Proposal for draft amendments to ECE/TRANS/WP.29/2010/53

(Regulation No. 83)

As a conclusion of the GRPE expert meeting on Euro-5 requirements (held in Geneva on 12 January 2010), this document was prepared by the experts from the European Commission to update and clarify the amendments to Regulation No. 83 with regard to the Euro 5 emissions level. It has been prepared as a revised version of document ECE/TRANS/WP.29/2010/53. The amendments to that document are marked a grey highlighted characters.

ARRANGEMENTS OF THE APPROVAL MARK

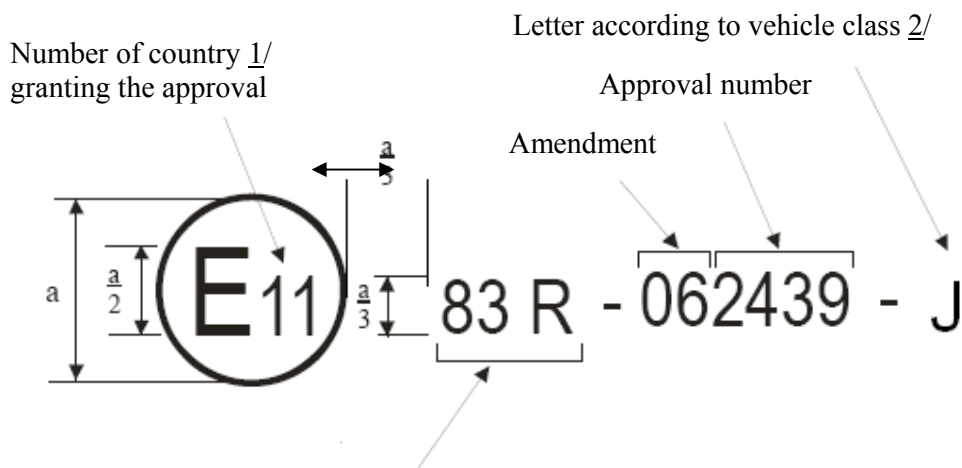
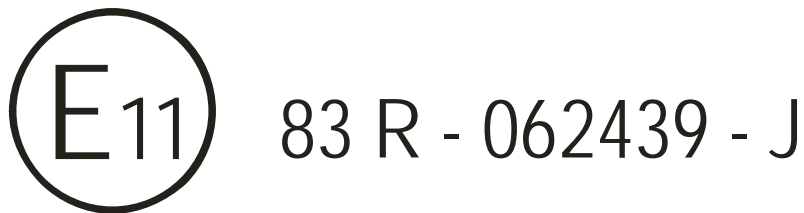
Annex 3, amend to read:

In the approval mark issued and affixed to a vehicle in conformity with paragraph 4. of this Regulation, the type approval number shall be accompanied by an alphabetical character assigned according to Table 1 of this Annex, reflecting the vehicle category and class that the approval is limited to.

This annex outlines the appearance of this mark, and gives an example how it shall be composed.

The following schematic graph presents the general lay-out, proportions and contents of the marking. The meaning of numbers and alphabetical character are identified, and sources to determine the corresponding alternatives for each approval case are also referred.

The following graph is a practical example of how the marking should be composed.

Standard Bench Cycle (SBC)

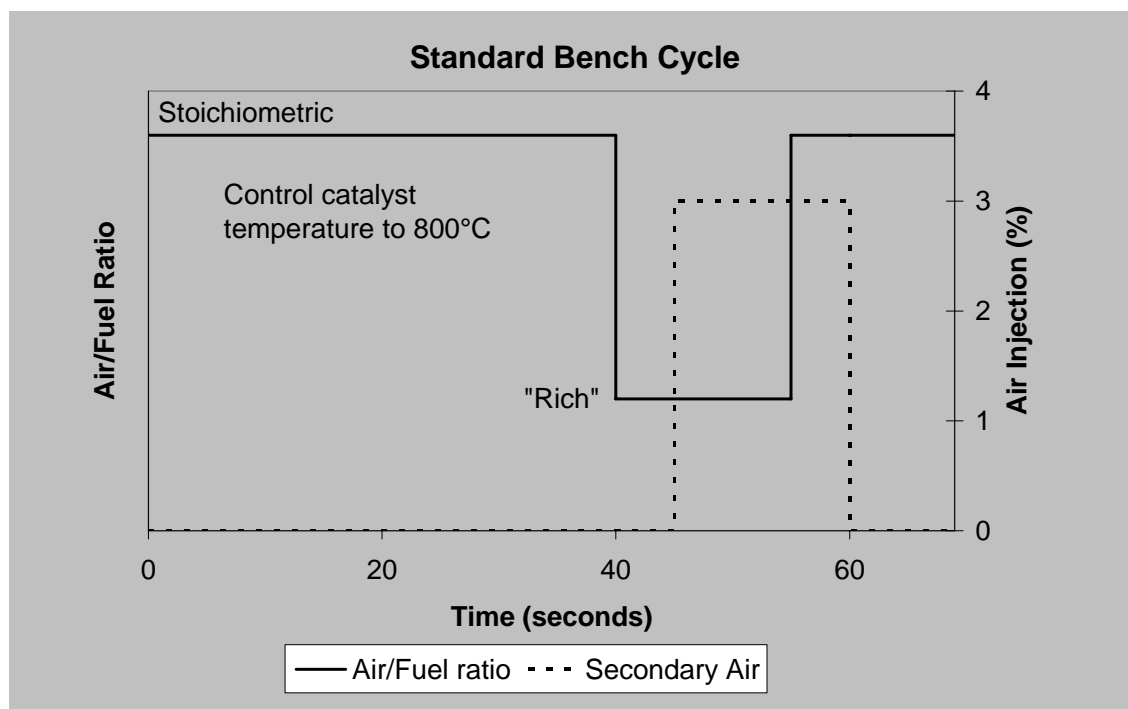
Insert Appendix 1- 3 into Annex 9

Appendix 1

Standard Bench Cycle (SBC)

2.2. Control the catalyst temperature at stoichiometric operation (01 to 40 seconds on the cycle) to a minimum of 800 °C (± 10 °C) by selecting the appropriate engine speed, load, and spark timing for the engine. Control the maximum catalyst temperature that occurs during the cycle to 890 °C (± 10 °C) by selecting the appropriate A/F ratio of the engine during the “rich” phase described in the table below.

The standard road cycle is represented graphically in the following figure:

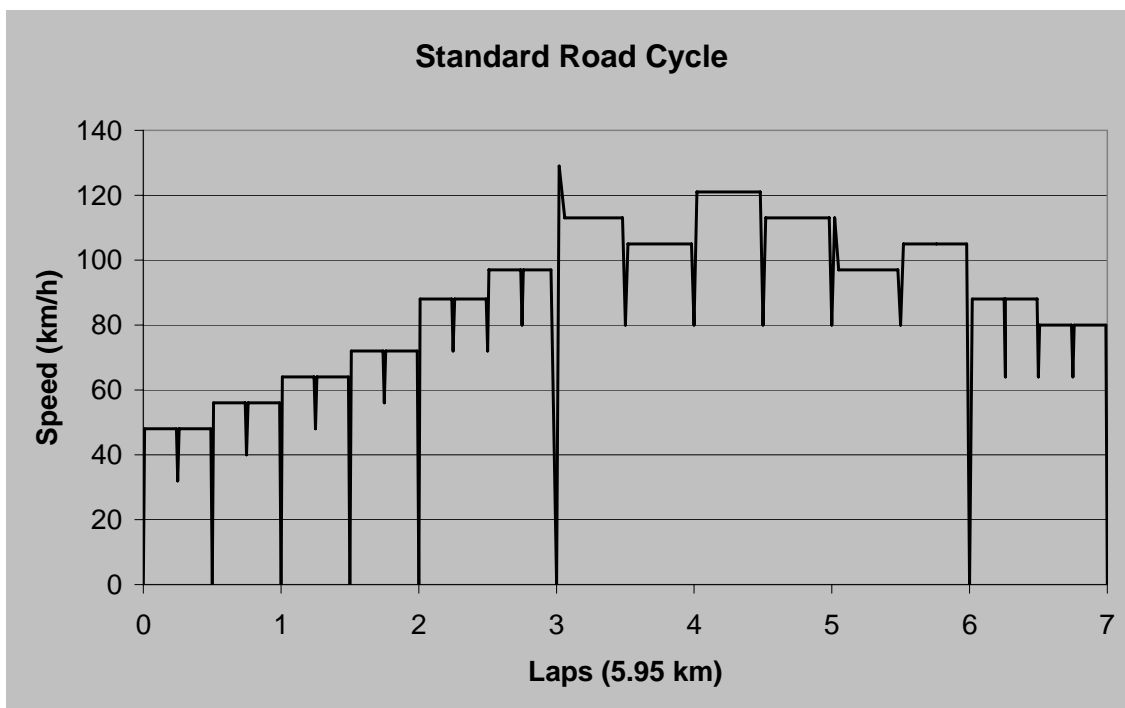
Standard Road Cycle (SRC)

The standard road cycle (SRC) is a kilometre accumulation cycle. The vehicle may be run on a test track or on a kilometre accumulation dynamometer.

The cycle consists of 7 laps of a 6 km course. The length of the lap may be changed to accommodate the length of the mileage accumulation test track.
